PLANNING COMMISSION

July 26, 2016

SUBJECT: PUBLIC HEARING - SPECIAL USE REQUEST AND PRELIMINARY SITE PLAN REVIEW (File Number JPLN2016-0020) – Proposed Rite Aid Pharmacy Drive Through Addition, Southeast Corner of South Boulevard and Crooks (1981 W South Boulevard), Section 04, Currently Zoned NN “U” (Neighborhood Node “U”) District

SUBJECT: PUBLIC HEARING - SPECIAL USE REQUEST AND PRELIMINARY SITE PLAN REVIEW (File Number SU JPLN2016-0017) – Proposed 1-800 Self Storage Facility, East side of Coolidge, South of Maple (1330 Coolidge), Section 32, Currently Zoned MR (Maple Road) District

1 SITE PLAN
SP-1 SCALE: 1" = 20'-0"

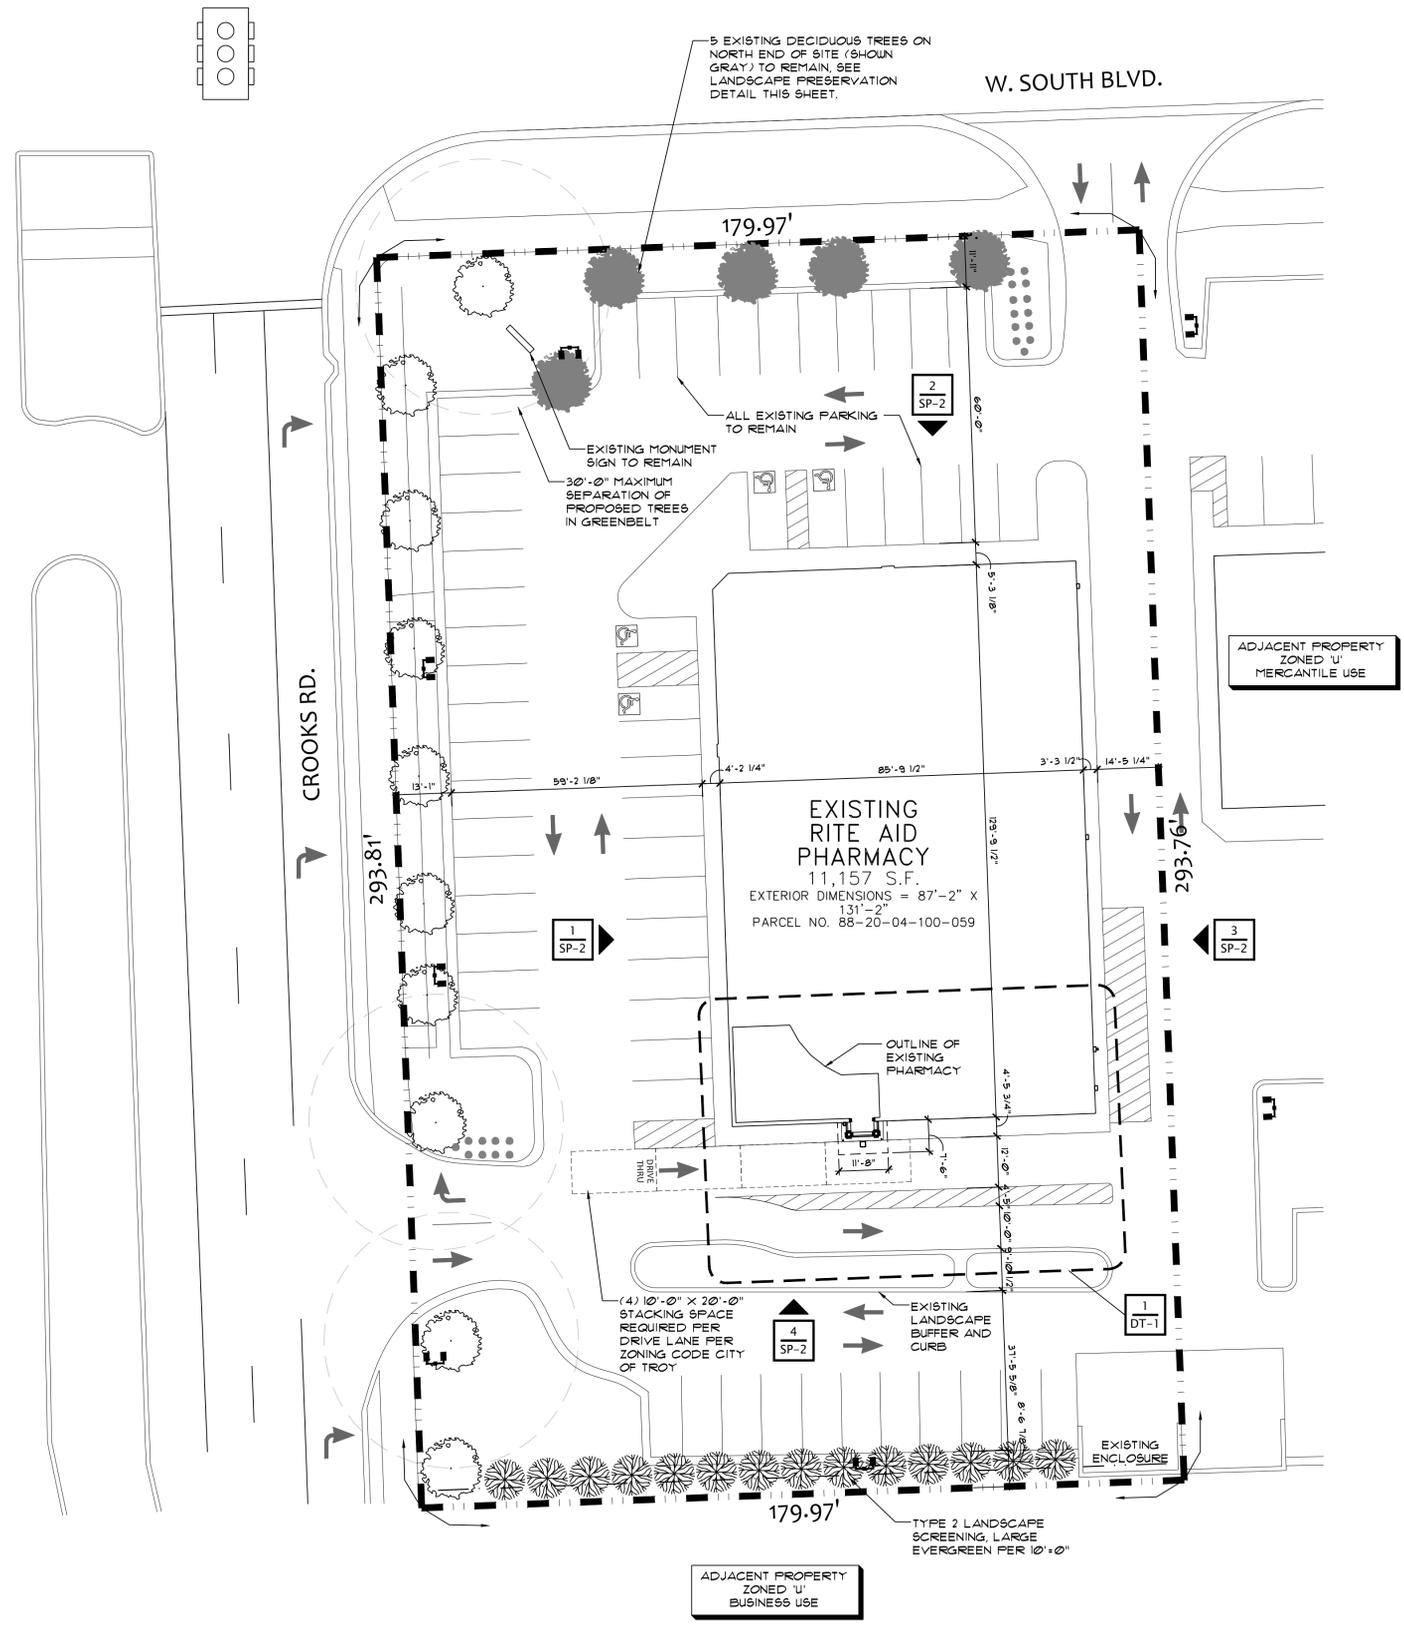
The applicant has shown additional landscaping on sheet SP-1; however, has not indicted size or species. The applicant should submit a complete landscape plan.

Items to be Addressed: Submit a complete landscape plan.

1 PHOTOMETRIC SITE PLAN
SP-4 SCALE: 1" = 20'-0"

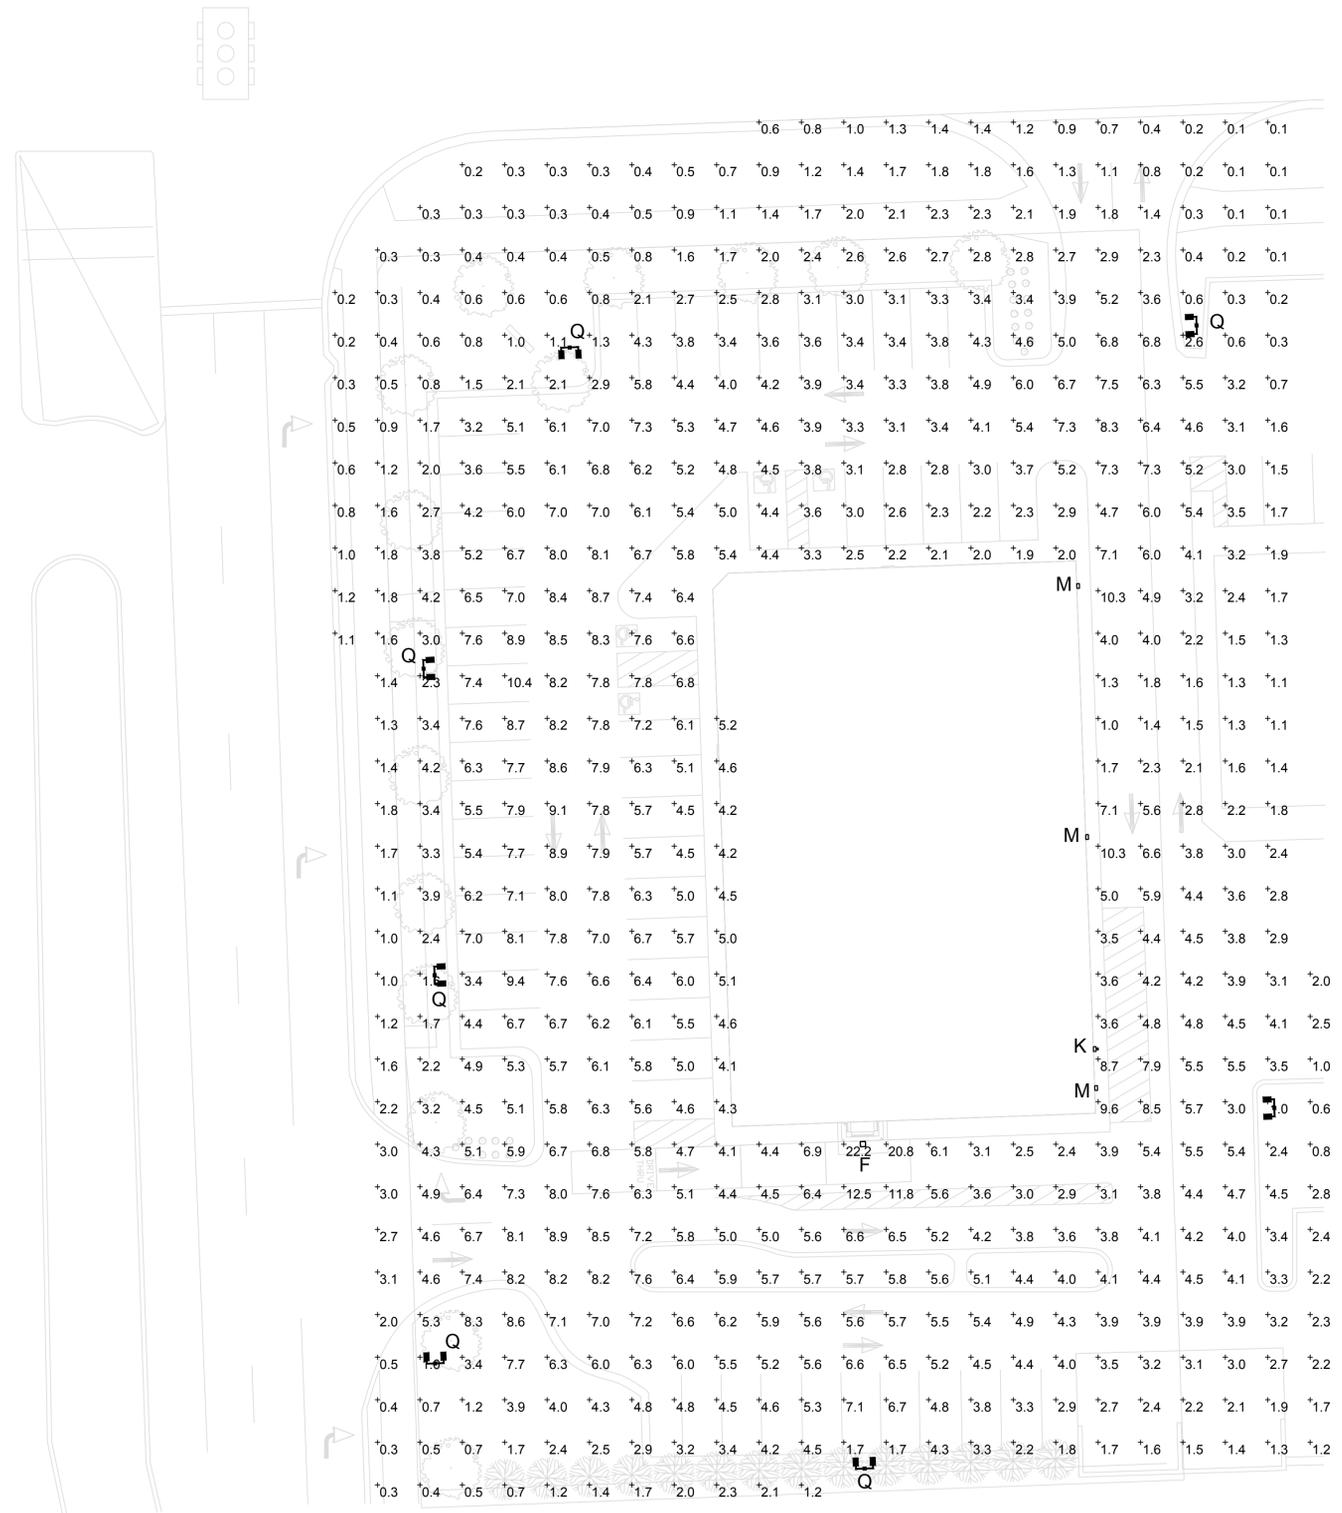
The applicant has provided a lighting plan, which appears to simply the existing lighting on site. Lighting is not compliant in regards to both fixture type and photometric levels. Applicant should submit a photometric plan in compliance with Article 13.

Items to be Addressed: Submit a photometric plan in compliance with Article 13.
